1 WESTERN EXTERNAL STAIRCASE 1:25
SCOPE OF REFURBISHMENT

Title: NUMBERING MARK UP OF WESTERN EXTERNAL STAIRCASE
Drawing number: 2332-24-211-01
Date: Dec 2016

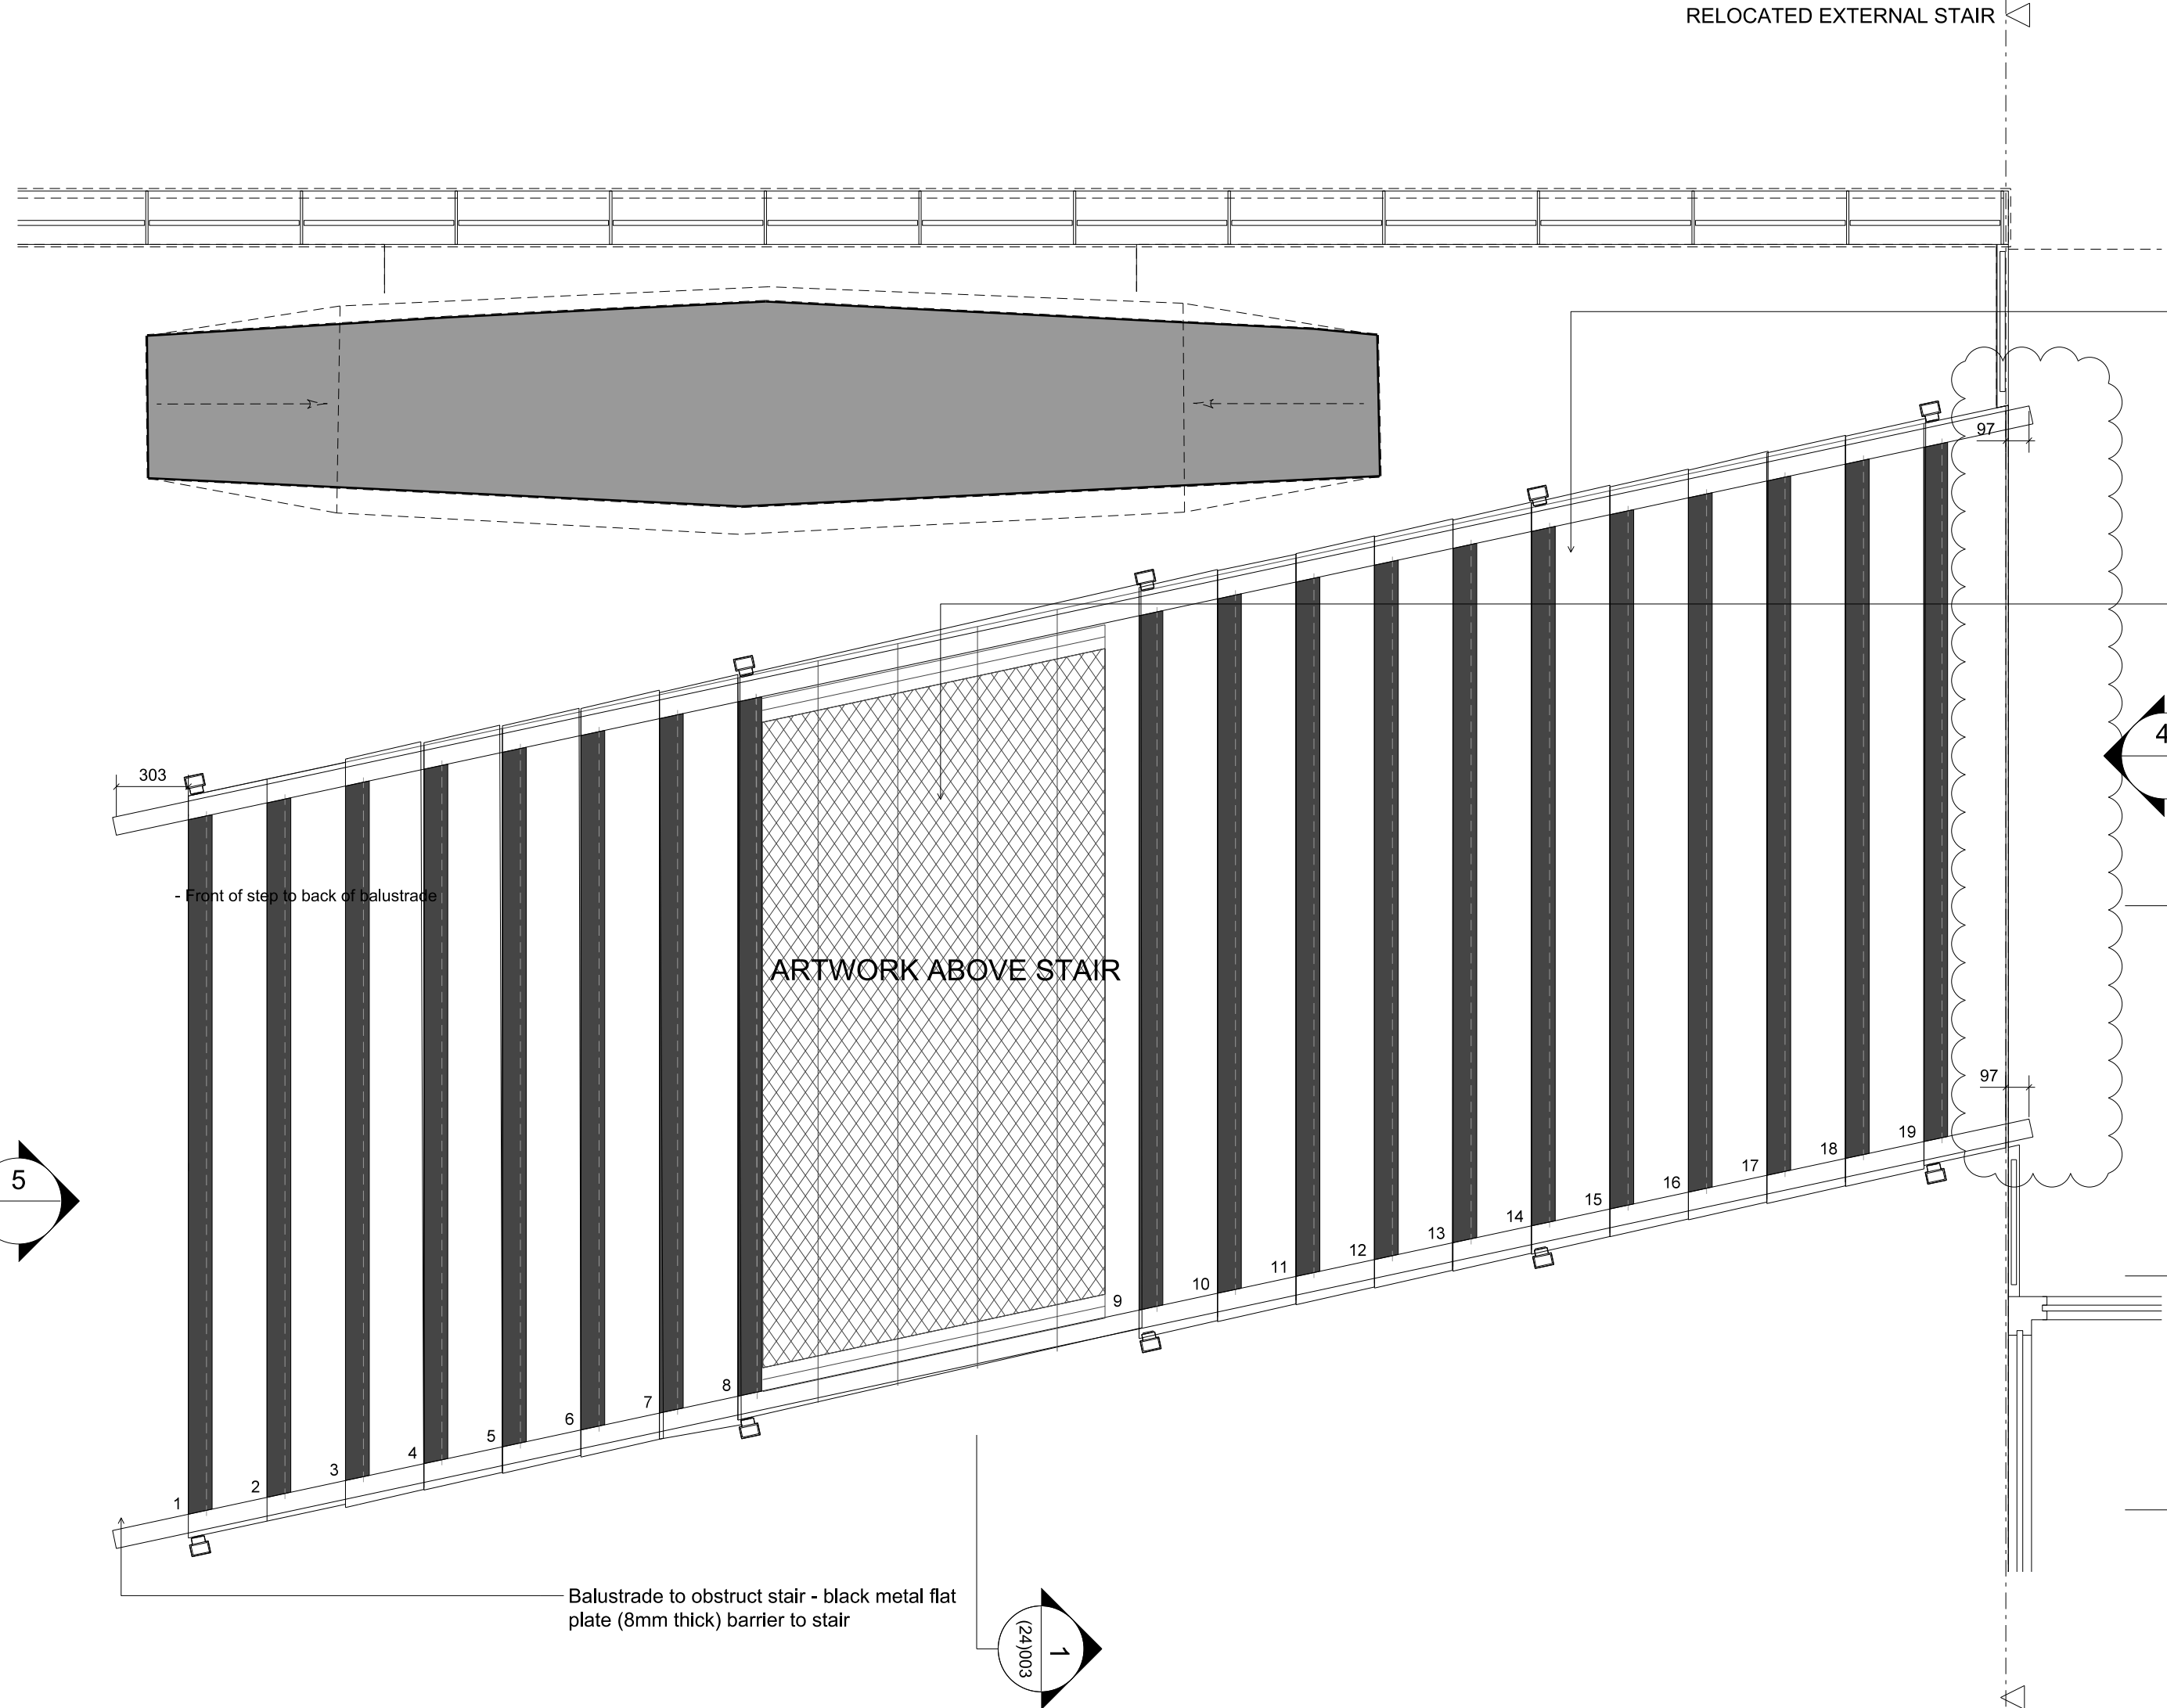
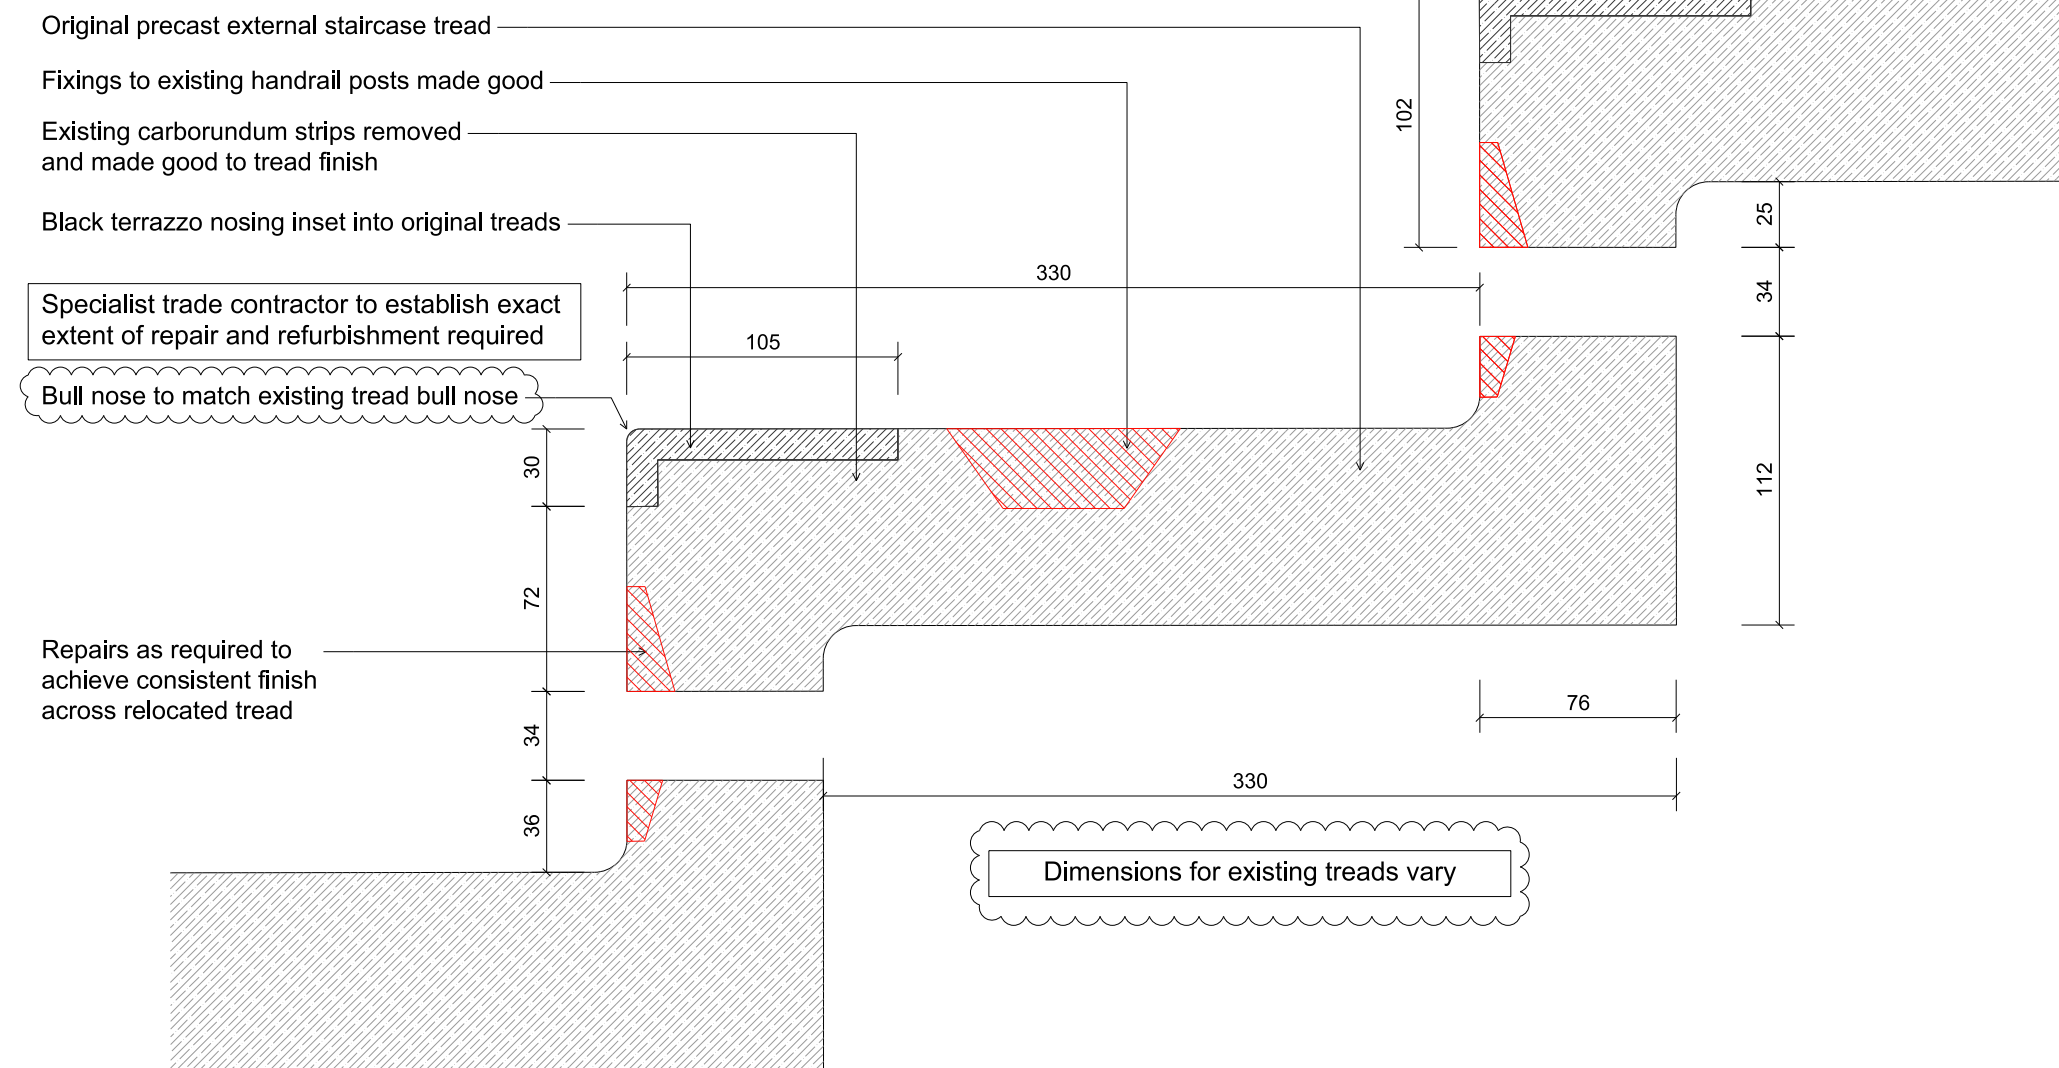
Existing treads shown are taken from PC 3d survey in the same sequence (as agreed with BMCE 28/4/16) and are shown indicatively only. PAYE to allocate retained treads and propose locations for replacement/new treads

Existing treads shown are taken from PC 3d survey in the same sequence (as agreed with BMCE 28/4/16) and are shown indicatively only. Treads shown do not reflect the location or quantity to be re-used.

Existing engraved pattern to landing slabs retained and made good to comply with BS 8300, holes to be not greater than 13mm wide

C&P recommend that top treads are new (replaced) to ensure that upper tread is consistent and parallel to slab (at 10mm). C&P recommend that 1st step is new (replaced) tread to maintain offset dim shown in C&P drawings.
